Access Compliance Report

Public Rights-of-Way

(Curb Ramps)

Intersection ID: 12695	Main Street: S_CALDWELL_ST	Cross Street: E TRADE ST	Location: NE
ADA ID: F4F93901A1B6	Ramp Type: Perp	Initial Pass/Fail: Fail	Overall Compliance: No
Codes/Mitigation Info/Possible Solution			Severity Score: 22.5
			Field Measurements/Component Compliance

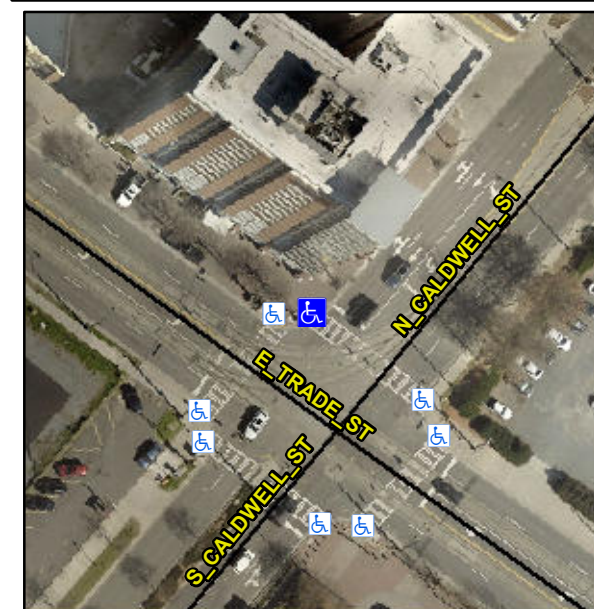
Not Found, R304.5.1, R304.2.2, R304.5.3

Compliance	Description	Data	Compliance	Description	Data
N/A	Ramp Length (in)	66.0	No	Ramp Slope (%)	8.6
No	Ramp Width (in)	47.0	No	Ramp XSlope (%)	3.4
N/A	Flare Type LT	N/A	N/A	Flare Type RT	N/A
N/A	Flare Slope LT (%)	N/A	N/A	Flare Slope RT (%)	N/A
N/A	Flare Traversable LT?	N/A	N/A	Flare Traversable RT?	N/A
N/A	Landing Length (in)	N/A	N/A	DWS Provided?	N/A
N/A	Landing Width (in)	N/A	N/A	DWS Contrast?	N/A
N/A	Landing Slope (%)	N/A	N/A	DWS Length (in)	N/A
N/A	Landing X Slope (%)	N/A	N/A	DWS Full Width?	N/A
N/A	Landing Curb? (Y/N)	N/A	N/A	DWS Offset (in)	N/A
N/A	Shared Landing?	N/A			
N/A	Gutter Ponding?	N/A	N/A	Gutter Slope (%)	N/A
N/A	Gutter Lip Ht (in)	N/A	N/A	Gutter X Slope (%)	N/A
N/A	Painted X Walk1?	Yes	N/A	Painted X Walk2?	N/A
	X Walk 1 Direction	To SE		X Walk 2 Direction	N/A
N/A	X Walk 1 Width (in)	112.0	N/A	X Walk 2 Width (in)	N/A
	X Walk 1 Slope (%)	1.4		X Walk 2 Slope (%)	N/A
	X Walk 1 X Slope (%)	3.0		X Walk 2 X Slope (%)	N/A

Remove & Replace Entire Ramp.
